Report on Nuclear Decommissioning February 28, 2011

**For
The California Public Utility Commission**

Figure 4.1 - SONGS 2&3 and DCPD Estimate Differences

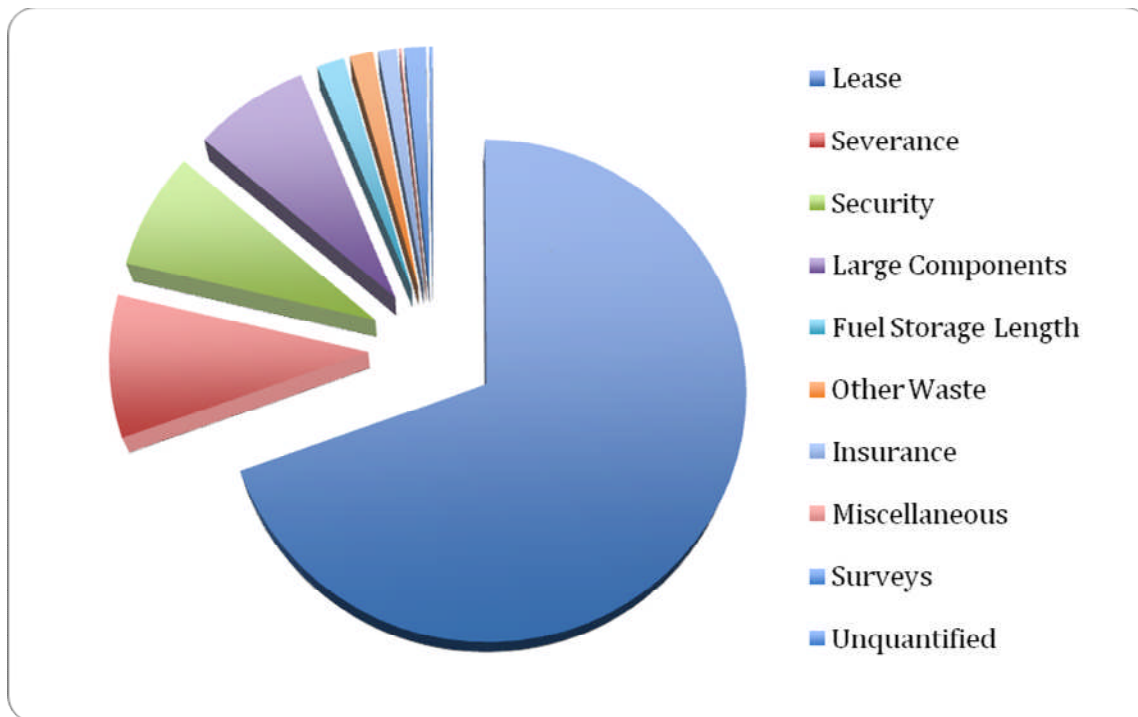
The primary difference between the SONGS 2&3 and DCPD estimates identified by the Panel is the assumed site condition at the end of decommissioning. The SONGS station is located on land leased from the United States Navy (Navy Lease).¹⁶ The Navy Lease provides requirements related to the restoration of the site prior to termination of this lease. Generally, the Navy Lease requires that any and all improvements installed or constructed be removed, and the site restored to a satisfactory condition, including decontamination of the site and surrounding area resulting from operation of the station.¹⁷ In addition, SCE has a separate lease from the California State Lands Commission (State Lands Lease) for its offshore water circulating conduits.¹⁸ The State Lands Lease requires that the conduits be excavated and removed in their entirety.

The two estimated costs reflect this difference. The SONGS 2&3 estimate assumes that all material added to the site by SCE is removed during decommissioning. The DCPD estimate assumes that most radioactive material is removed, and that all structures above three feet below grade are removed.¹⁹ As a result of these differing scopes, the SONGS 2&3 estimate calculates that approximately 2.8 billion pounds of material will be removed from the site during decommissioning, and the DCPD estimate approximately 1.0 billion pounds of material.

The Panel calculated that the direct activity cost associated with the added material was approximately \$300 million, the disposition cost approximately \$194 million, and the indirect cost approximately \$840 million (all 2008 dollars, including 25 percent contingency). The Panel recommends that a more accurate value be determined for future NDCTP by developing a decommissioning cost estimate specifically for the desired scope.²¹

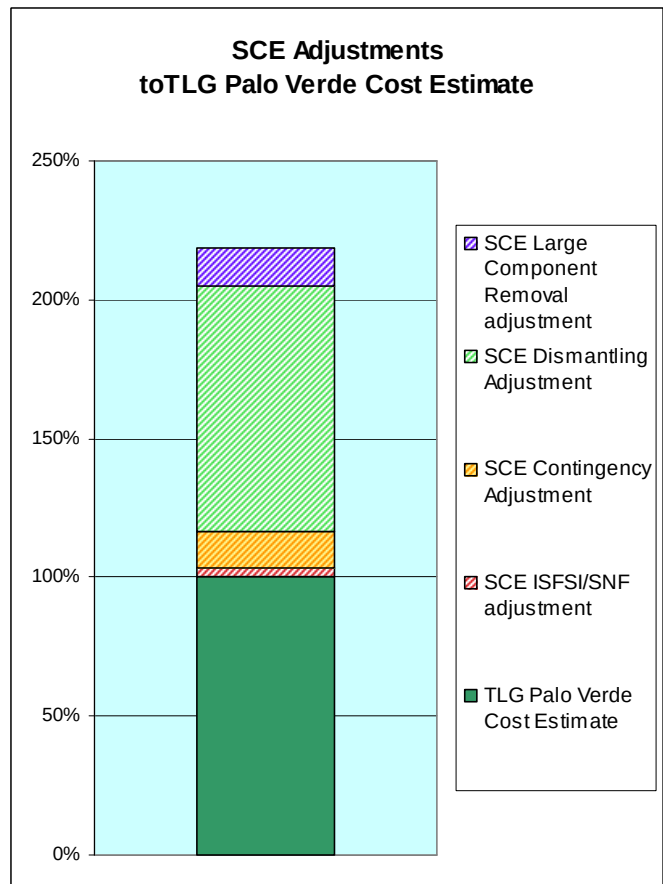
The Panel is not opposed in principle to adjustments to decommissioning cost estimates, and understands that different owner interests and regulatory policies may make such adjustments appropriate.

The Panel examined each of these adjustments and the supporting basis with the following results:

The net dismantling and disposal adjustment is the largest adjustment and is based on the premise that the LLRW Class A direct burial waste volumes reported in the 2007 PV study represent the total volume of Class A waste to be disposed of. This direct burial waste volume in the 2007 study is less than the total expected by SCE based on the 1998 PV decommissioning cost estimate study and they adjusted the 2007 study cost to reflect a direct burial waste volume corresponding to the 1998 study. This adjustment by SCE is incorrect, however, in that it does not include the significant volume of Class A waste to be disposed of through waste processing and conditioning which is included in the 2007 PV report. The result of SCE not including the volume of processed waste is that the SCE adjustment should be substantially reduced. Any future use of an adjustment related to waste burial volume needs to include consideration of the waste volumes to be disposed of through processing and conditioning. The basis for this misunderstanding appears to originate in 2001 when the separation of Class A waste

Chart 5.1 - Total Cost Comparison

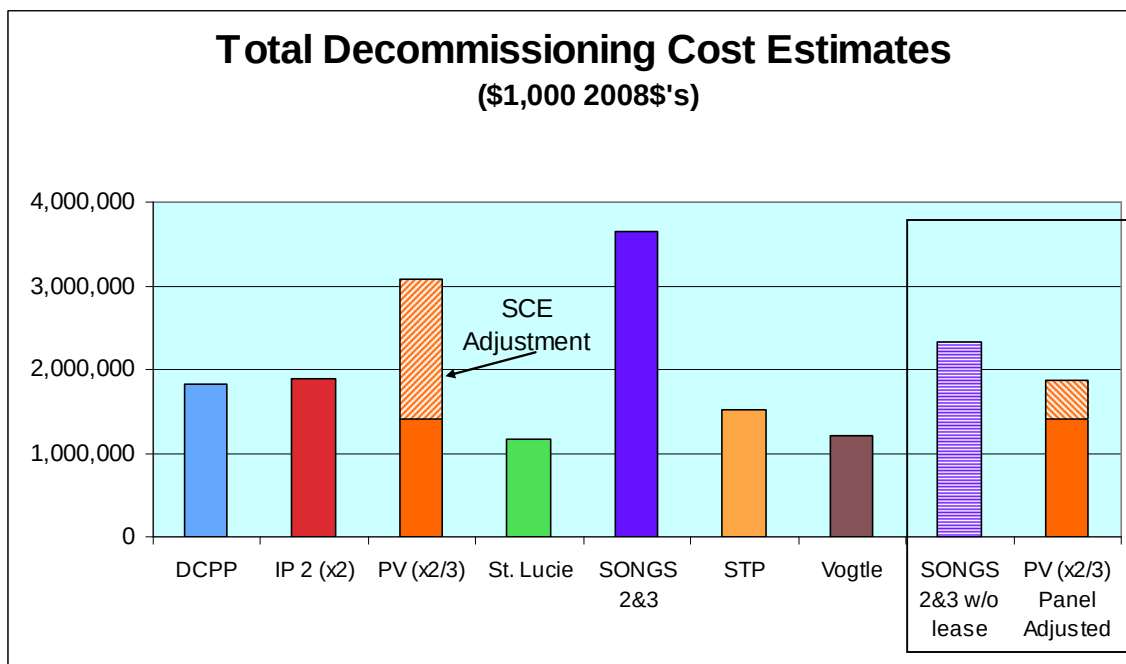
The chart shows a range of estimates with the lowest being St. Lucie and the highest being SONGS 2&3. Setting aside SONGS 2&3, no estimate is less than \$1 billion and no estimate is greater than \$2 billion. The SCE adjustments to PV, discussed in section 4, more than double the estimator/operator provided cost estimate, and when included make it the second highest estimate on the chart. Explanations for the variation in the estimates in the \$1 to \$2 billion range include size (St. Lucie is the smallest), labor costs (DCPP and IP are higher wage rate areas), seismic design issues (DCPP and SONGS 2&3 in the Pacific Rim earthquake zone), contingency (DCPP and SONGS 2&3 use higher contingency than the other plants) and the presence of steam generators or other large components waiting to be disposed of as part of final decommissioning (St. Lucie has shipped its retired steam generators). Other issues include the timing of when estimates were done and site/design factors.

Chart 5.5 – Wet Fuel Storage Phase

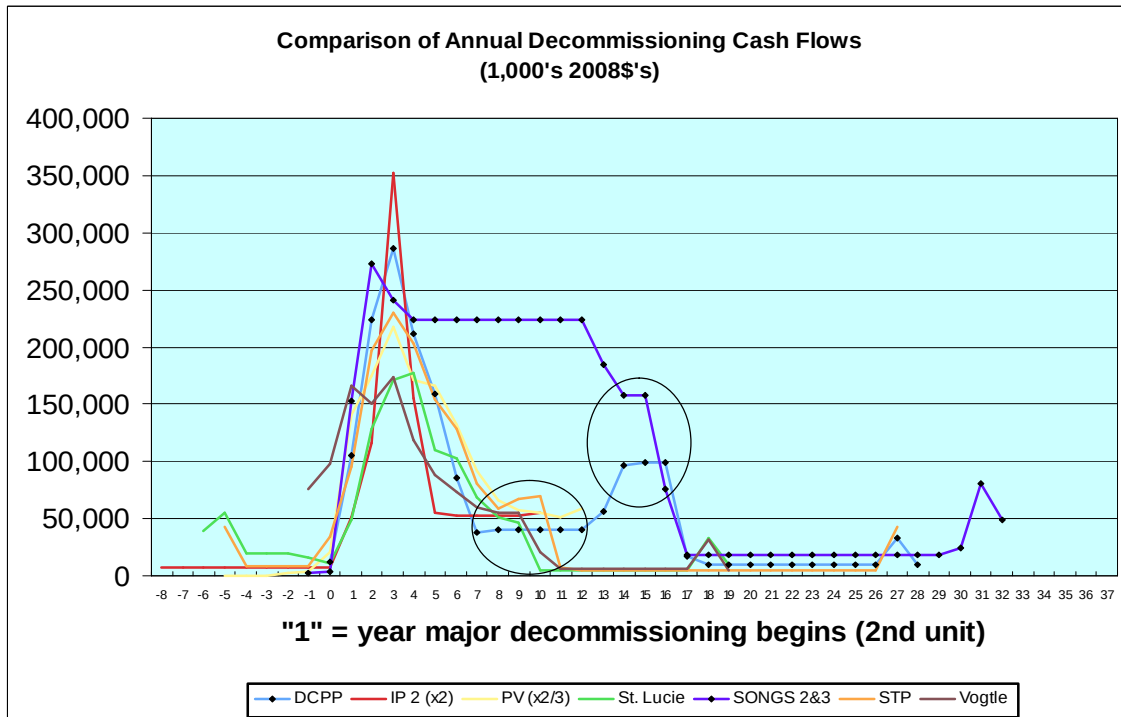
The two circled areas on the chart illustrate a major difference between the DCP and SONGS 2&3 cost estimates and the cost estimates for the other sites (except IP 2 which will be discussed separately) and the differences are significant.

Chart 5.8 – Waste Volume

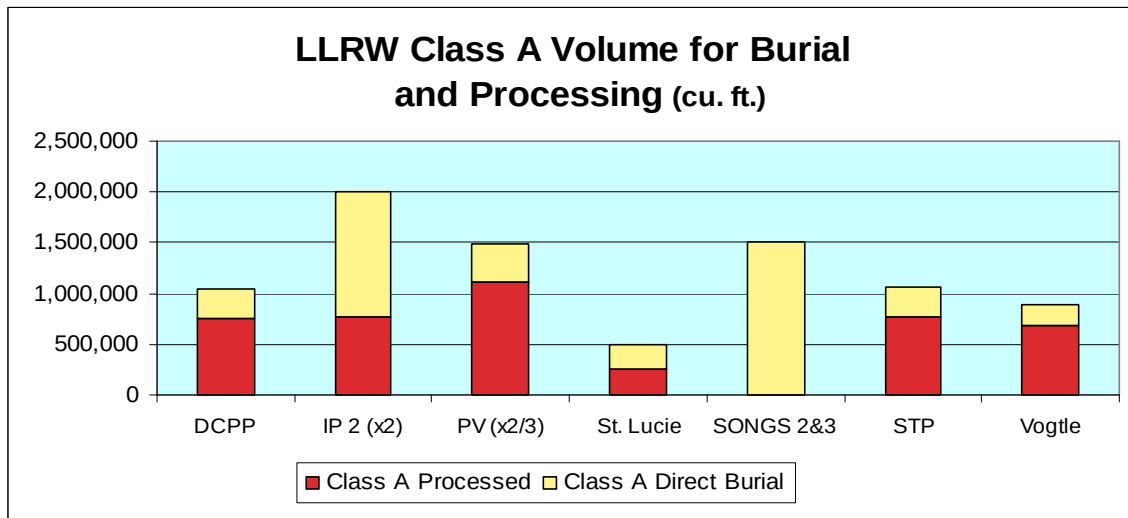
The site totals for class A waste volume vary significantly. St. Lucie is lowest with 500,000 cu. ft. of material and IP is highest with four times as much, or 2,000,000 cu. ft. Three sites, DCP, STP and Vogtle cluster in the 1,000,000 cu. ft. range. Total decommissioning cost (chart 5.1) varies in a similar manner to this chart, but notable exceptions are IP 2 and PV, which have waste volumes equal to or higher than SONGS 2&3.

Generally, the processing/conditioning portion of the volume represents a slightly lower unit cost than the direct burial unit cost; hence the large volume of waste at PV, the majority of it addressed as processed/conditioned, does not drive the overall cost estimate higher in proportion to total waste volume. Variations in estimated costs for burial and processing/conditioning can increase or remove the advantage of using processing/conditioning.
